The New Piper Aircraft, Inc.
 2926 Piper Drive
 Vero Beach, Florida, U.S.A. 32960

SERVICE No. 1051B BULLETIN

Date: November 5, 2002 (M)

SUBJECT: FLAP TORQUE TUBE REPLACEMENT

Acceptable Limits for Oblong Hole
(Angle to Center Line is not Critical)

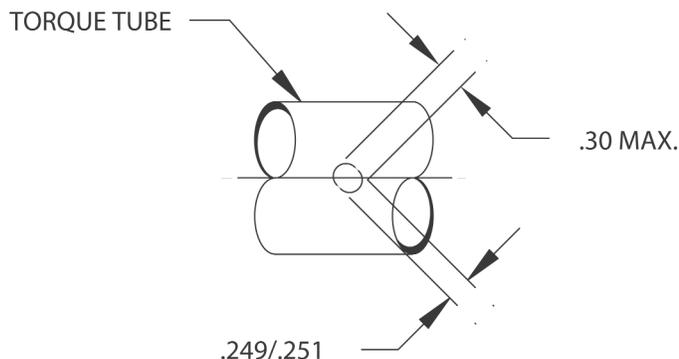
- Examine the holes for the attachment bolts for the Flap Control Horn and the Flap Bellcrank for cracks originating out of the hole using Fluorescent Penetrant procedure per FAA AC43.13 Repair Manual, Nondestructive Testing. Also, inspect for elongation of the subject holes. Elongation up to .050 (see sketch) is acceptable provided that when the horn or bellcrank is mounted on the tube with the attachment bolts (without nuts) installed, there is no relative motion between the horn or bellcrank and the torque tube with a light load applied in a radial direction simulating a flap air load. Proceed to Instruction 5 if cracks are noted in the subject holes or elongation exceeds limits.

Flap Control System Detail
SKETCH A

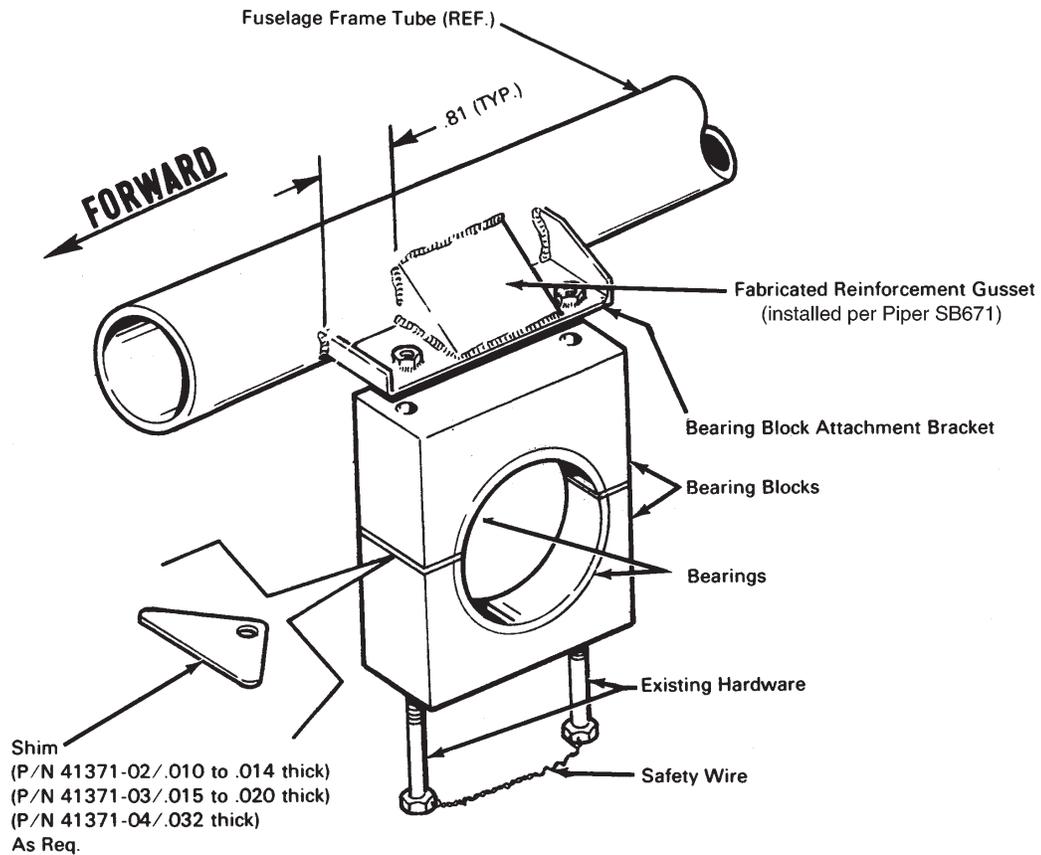
3. Remove the flap torque tube assembly as follows:
- Disconnect the flap control rods allowing both flaps to hang freely.
 - Remove the left and right rear wing root fairing and left and right flap torque tube access panels at station 123.75. (Refer to Sketch A.)

- Remove the locknut from the sender unit rod installed through the torque tube and remove the rod. (Refer to Sketch A.)
 - Remove the bellcrank assembly from the right side of the flap torque tube assembly by first removing the bolt, washers and nut attaching the flap actuating cylinder to the bellcrank arm. Next, remove the two bolts, washers, nuts and cotter pins installed through the bellcrank housing and torque tube. Then remove the bellcrank assembly from the flap torque tube. (Refer to Sketch A.)

5. Install the replacement p/n **104622-004** flap torque tube assembly as follows: (Refer to Sketch A).
- a. Install the flap bellcrank on the right end of the replacement tube. Rotate the bellcrank until the scarf on the bellcrank matches the scarf on the tube. With the use of a transfer punch, mark the centerline of one of the .249/.251 holes in the bellcrank on the tube and drill an .189/.191 diameter hole thru one side only of the tube. Repeat the same process for the same hole on the opposite side of the bellcrank. Ream the .189/.191 diameter holes to .249/.251 diameter using the bellcrank as a guide. Temporarily install a .250 diameter bolt and nut. Repeat the same steps for the other hole in the bellcrank. After completing the reaming operation, remove the flap bellcrank from the replacement tube to allow it to be installed in the aircraft.

- b. On aircraft requiring the stabilator trim/flap interconnect pulley (PA-23-250, s/n 27-7640001 and up), slide the pulley bracket over the left end of the replacement tube and toward the right until the .249/.251 holes in the pulley bracket align with the .189/.191 pilot holes in the replacement tube located approximately 3.75 inches to the right of the replacement tube center. Using the pulley bracket as a guide, ream the .189/.191 holes to .249/.251 diameter holes. Attach the pulley bracket to the replacement tube using the appropriate hardware as shown in Sketch A.

- c. Install the flap horn assembly on the left end of the replacement tube. Rotate the horn until the scarf on the horn matches the scarf on the tube. With the use of a transfer punch, mark the centerline of one of the .249/.251 holes in the horn on the tube and drill an .189/.191 diameter hole thru one side only of the tube. Repeat the same process for the same hole on the opposite side of the horn. Ream the .189/.191 diameter holes to .249/.251 diameter using the horn as a guide. Temporary install a .250 diameter bolt and nut. Repeat the same steps for the other hole in the horn. Attach the horn bracket to the left end of the replacement torque tube using the appropriate hardware shown in Sketch A.

Flap Horn and Reinforcement Gusset Detail
SKETCH B

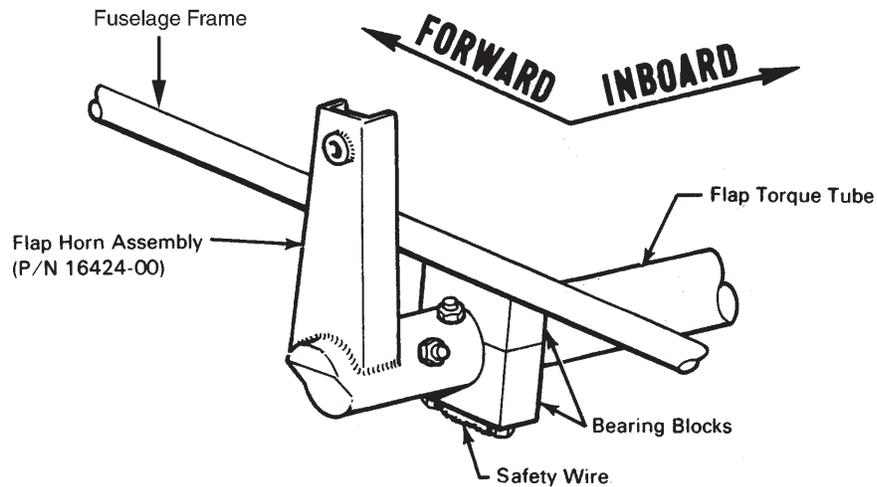
- Cut the safety wire from the bearing block bolts and remove the bolts, washers, bearing blocks, bearings, and shims, if installed, from each side. (Refer to Sketch B.)
